**General Bid Bulletin No. 6**

**METRO MANILA SUBWAY PROJECT PHASE I**

**PACKAGE CP103:  
TWO UNDERGROUND STATIONS (ANONAS AND KATIPUNAN)  
AND TUNNELS  
(IFB No: 21-035-6)**

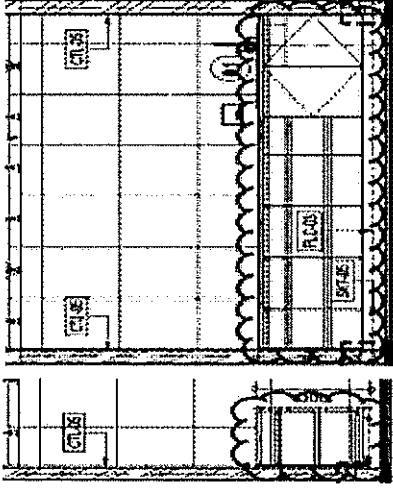
53.	14 / Arch_AN / STN-AR-A-AN-9001, 1600, 15 /		<p>The Typical wall type details (STN-AR-A-AN-9001) which indicates the height of upstand requirement with</p>

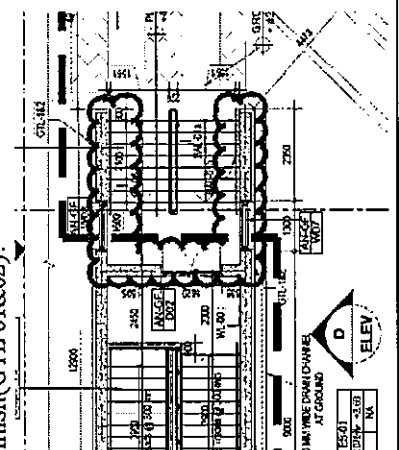
63.	14 / Arch_AN / STN-AR-A-AN-1100 - 1404,	<p>At Anonas &amp; Katipunan Stations, Doors &amp; Windows Size differs in STN-AR-A-AN-1100 - 1404</p>	<p>Follow station level plan STN-AR-A-AN/KP-1100 - 1404</p>

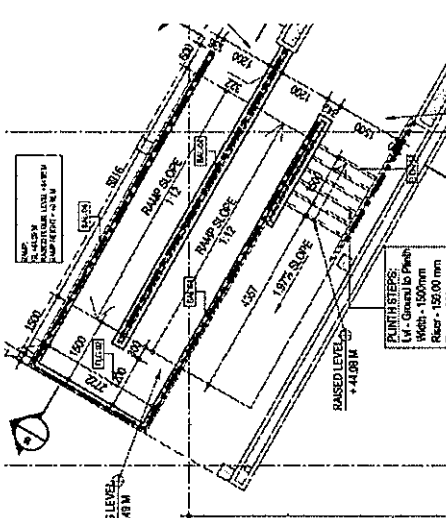
66.	14 / Arch_AN /	The door finish differs in TYPICAL DETAILS OF	Follow Typical door Details for finishes.

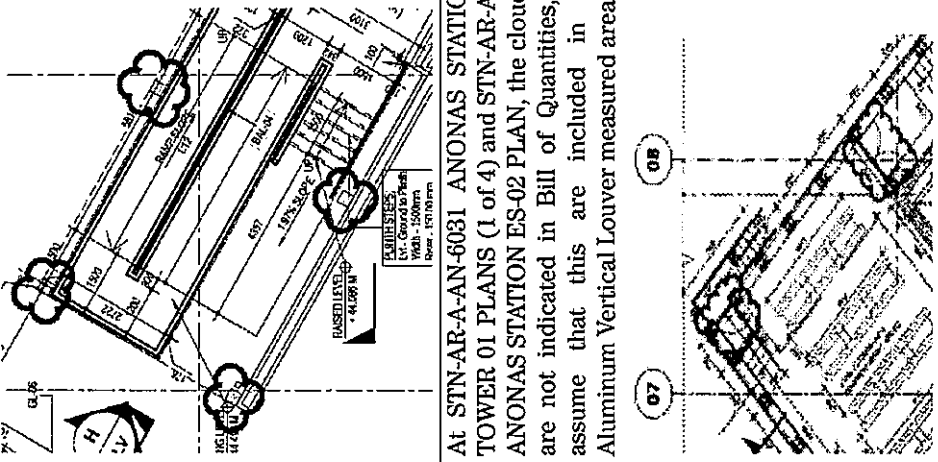
73.	14 / Arch_AN / STN-AR-A-AN-6051, 6052 Handrail	At Ground Level ES 01 Entrance Stairs (Grid 21/D), the specification of Wall-attached Stair Handrail differs as follows,  STN-AR-A-AN-6051 ANONAS STATION	The drawing STN-AR-A-AN-6051 indicating BAL-01b is correct one.

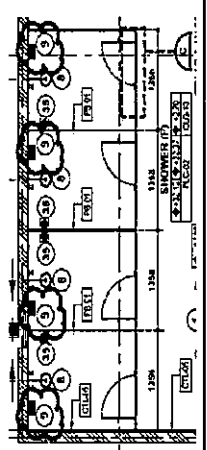
86.	14 / Arch_AN / STN-AR-A-AN-0501, 1702, 2603		<p>No trench in drawings. Follow STN-AR-A-AN-0501 ANONAS STATION FINISHING SCHEDULE (2 OF 2) and STN-AR-A-AN-2603 ANONAS STATION B2F LEVEL PLAN-FLOOR FINISHES (PART 04 OF 05)</p>

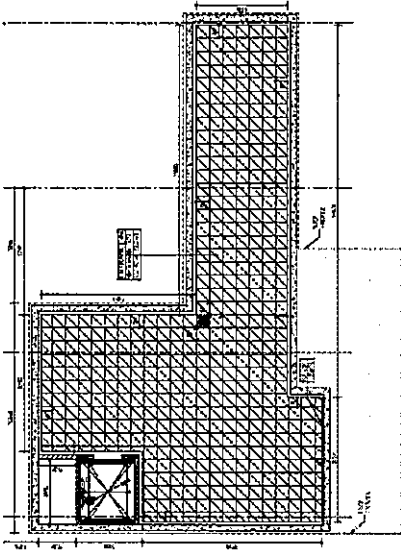
104	14 / Arch_AN / STN-AR-A-AN-6003, 7001	At B1F Unpaid Area (Grid 7-8/C), the shutter call out differs as follows,	Follow STN-AR-A-AN-7001 ANONAS STATION-B1F LEVEL-

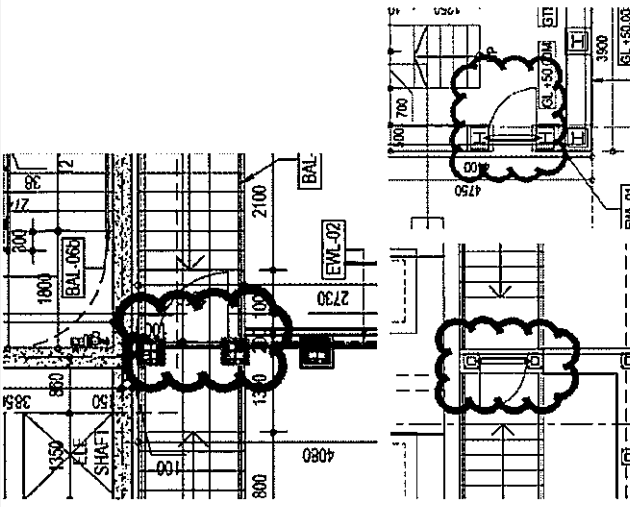
106	14 / Arch_AN / STN-AR-A-AN-1305, 7002 Door call out	<p>At B2F Machine Room (Grid 29/D), the door call out differs as follows, STN-AR-A-AN-1305 ANONAS STATION B2F LEVEL PLAN (PART-06 OF 06)</p>	<p>Follow STN-AR-A-AN-7002 ANONAS STATION-B2F LEVEL- DOOR &amp; WINDOW TAG AN-B2F D34 is correct one.</p>

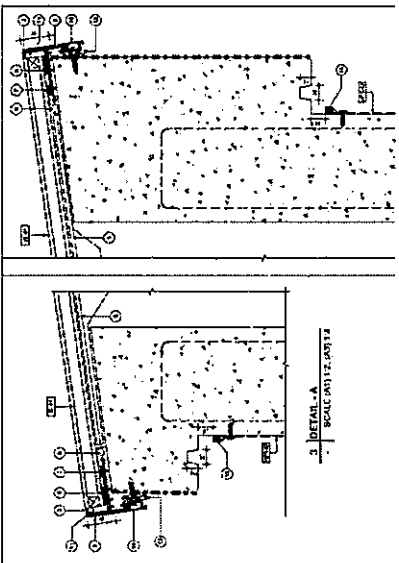
136	14 / Arch_AN / STN-AR-A-AN-9500,9501, 15 / Arch_AN / STN-AR-A-KP-9500,9501 Lining Finish		18mm thick phenolic board is under Pay item no. 1816.1(a1)
137	14 / Arch_AN / STN-AR-A-AN-9003,	At STN-AR-A-AN-9003, STN-AR-A-KP-9003 TYPICAL DETAILS OF GRANITE FIXING, may we	Yes, follow Dry type fixation.

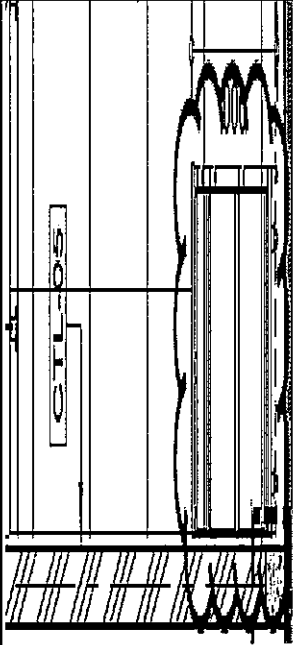
167	STN-AR-A-KP-7400, 1200 Katipunan - Office Furniture Station Store	<p>We noticed discrepancy in Qty of Furniture between Furniture Schedule STN-AR-A-KP-7400 against Drawing STN-AR-A-KP-1204: Please confirm if we can follow qty indicated in Furniture</p>	<p>Follow quantity in furniture schedule.</p>

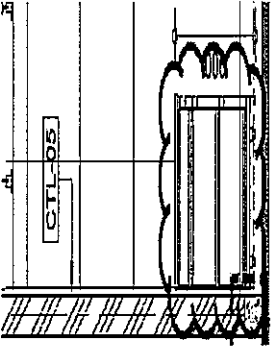
174	8_CP103_P2_S(VI)_(WR)_6(ED)_30 Mar2021_08_Civil_UT/ Drawing No.:	1) The drawing describes the situation where CP106 contractor installs their rails through the opening located at the north side shaft of	"Regarding the coordination with CP106 track works, please plan according to Volume II PART 2 WORKS REQUIREMENTS
